Connecticut Yankee Atomic Power Company

Notice of Receipt of UFSAR

Change No.: 04-04

**HADDAM NECK PLANT
FINAL SAFETY ANALYSIS REPORT
November 2004 Update
Insert Instructions**

UFSAR FIG. 8.1-2

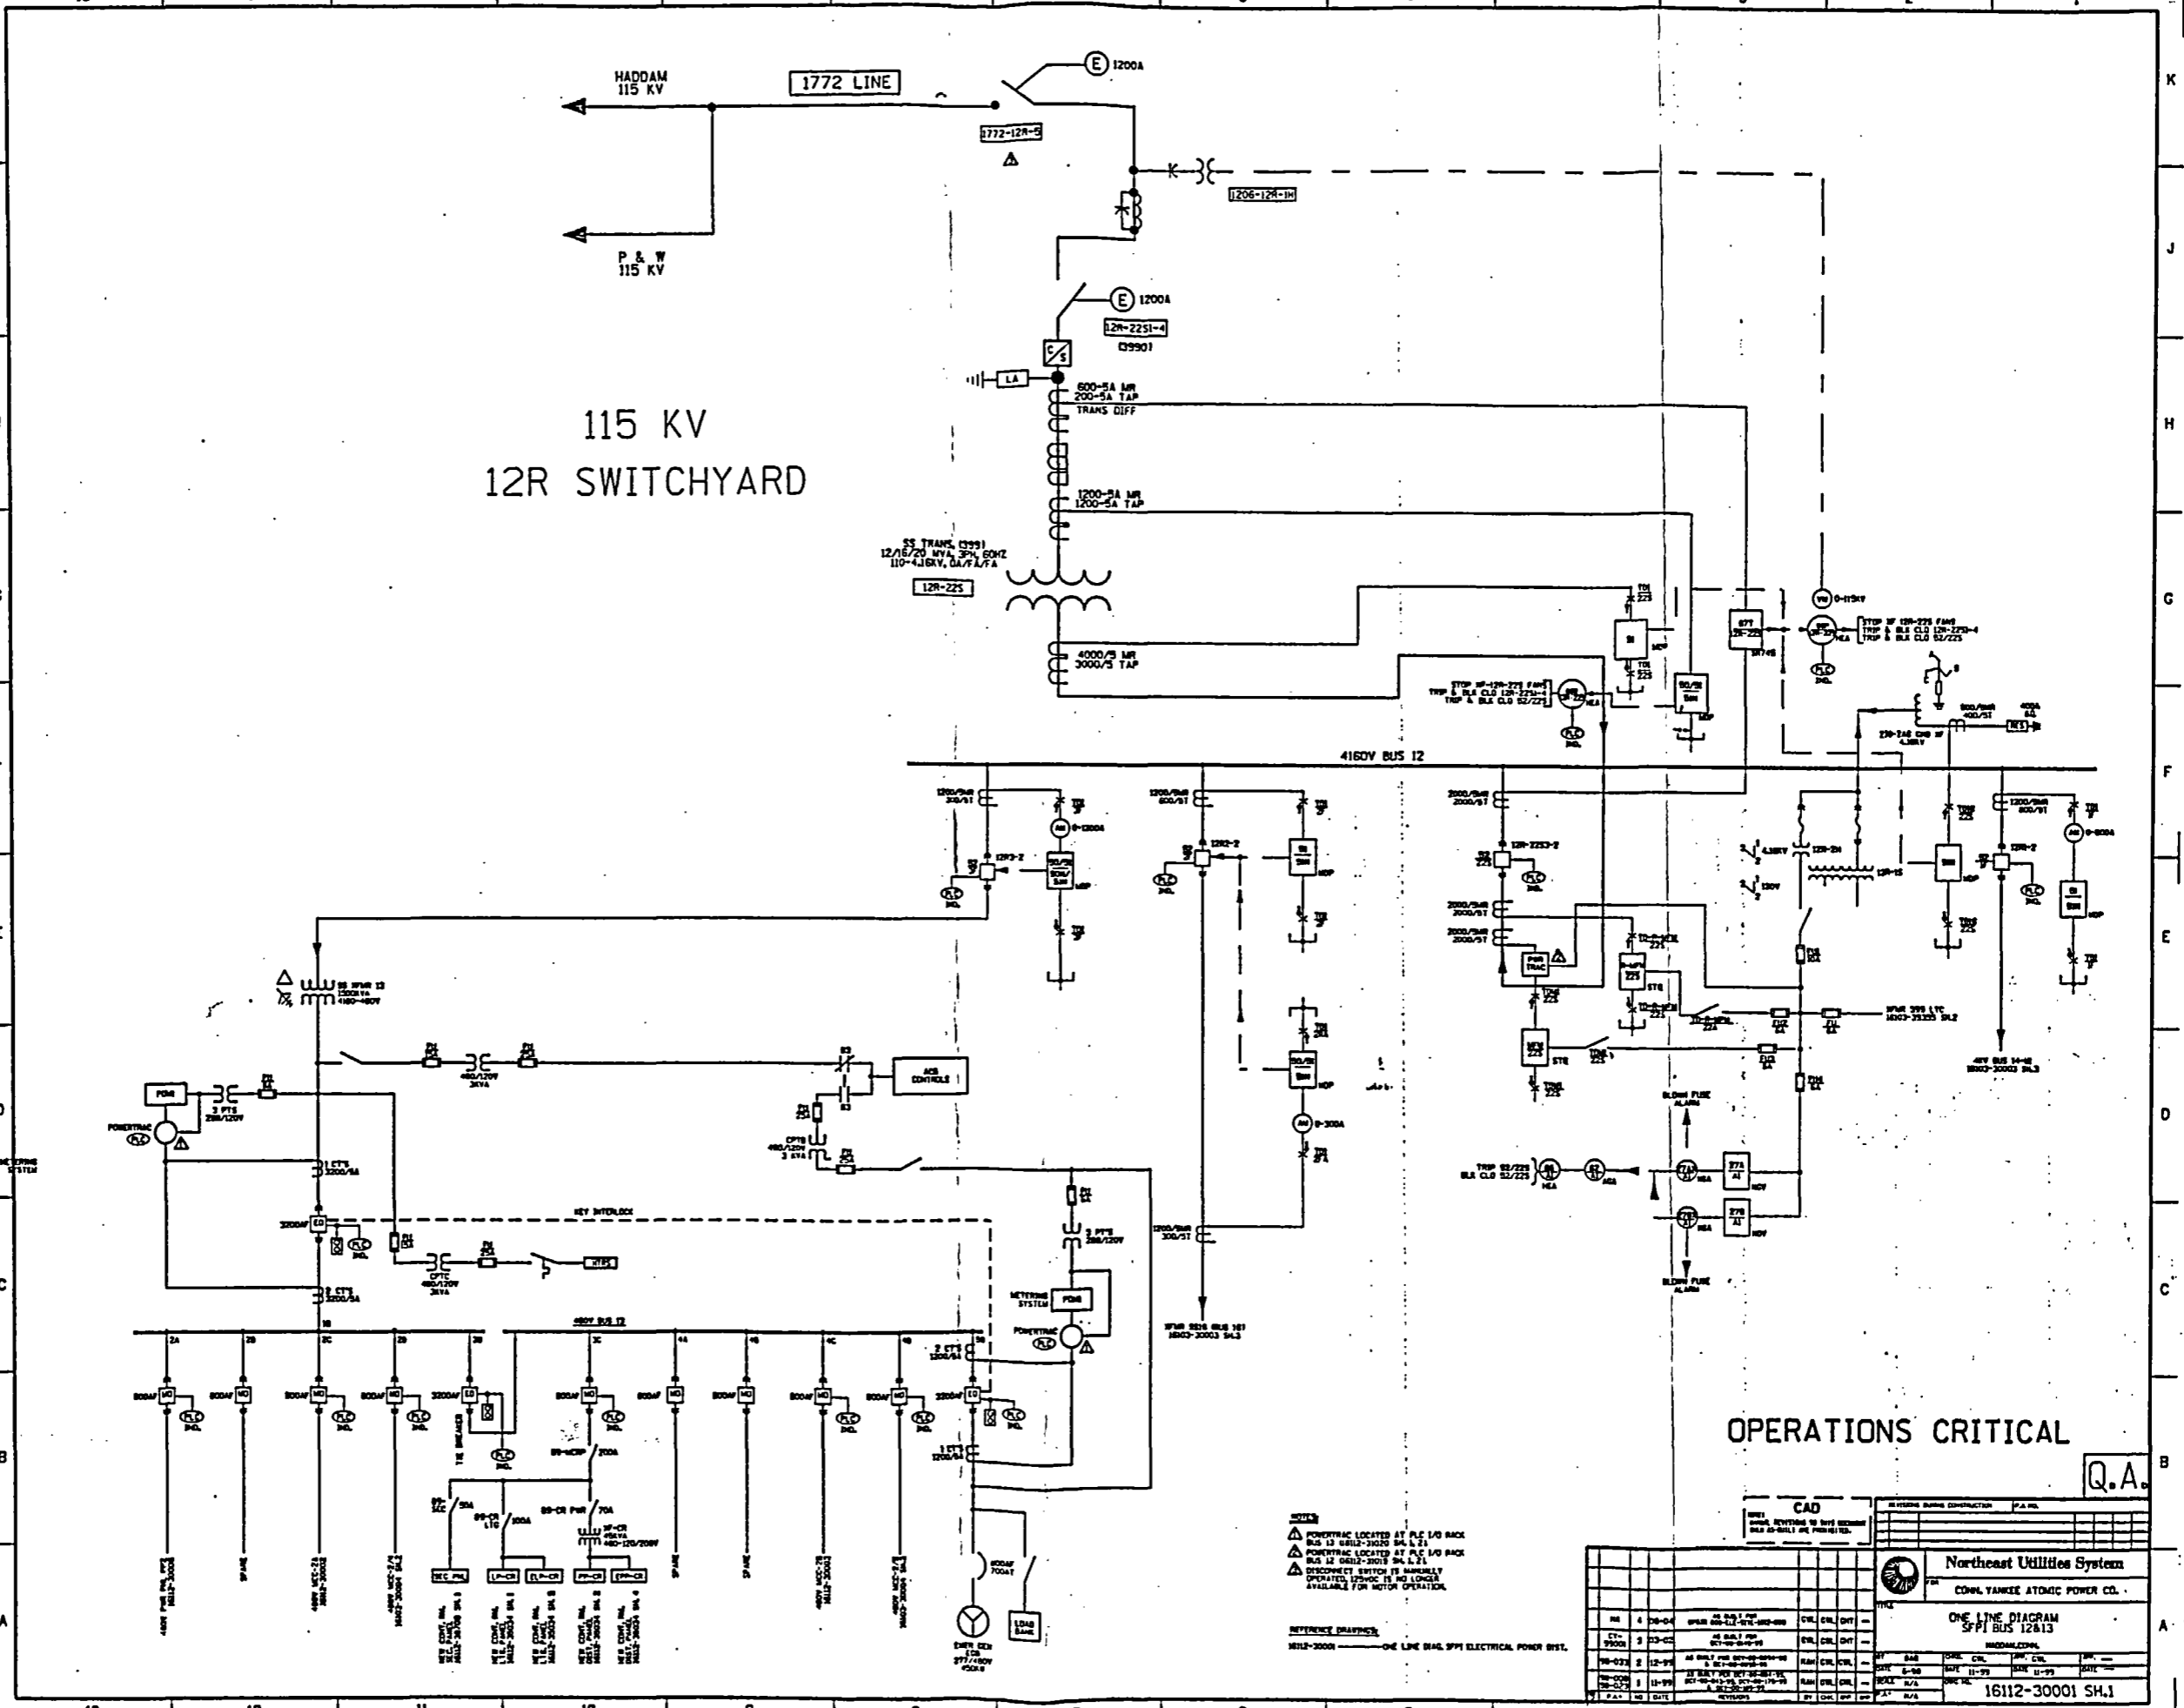
Chapter 3, Page 3.8-1	February 2004	Chapter 3, Page 3.8-1	November 2004	LBDCR #23
Chapter 8, Figure 8.1-1	July 2002	Chapter 8, Figure 8.1-1	November 2004	LBDCR #26
Chapter 8, Figure 8.1-2	July 2002	Chapter 8, Figure 8.1-2	November 2004	LBDCR #26
Chapter 8, Page 8.2-1	July 2002	Chapter 8, Page 8.2-1	November 2004	LBDCR #26
Chapter 11, Page 11.5-3	July 2002	Chapter 11, Page 11.5-3	November 2004	LBDCR #35

- ⚠ POWERTRAC LOCATED AT PLE 1/20 BACK BUS 12 CHOLE-3003 SH.1.1
- ⚠ POWERTRAC LOCATED AT PLE 1/20 BACK BUS 12 CHOLE-3003 SH.1.1
- ⚠ DISCONNECT SWITCH IS MANUALLY OPERATED (SWOCC IS NO LONGER AVAILABLE FOR MOTOR OPERATION)
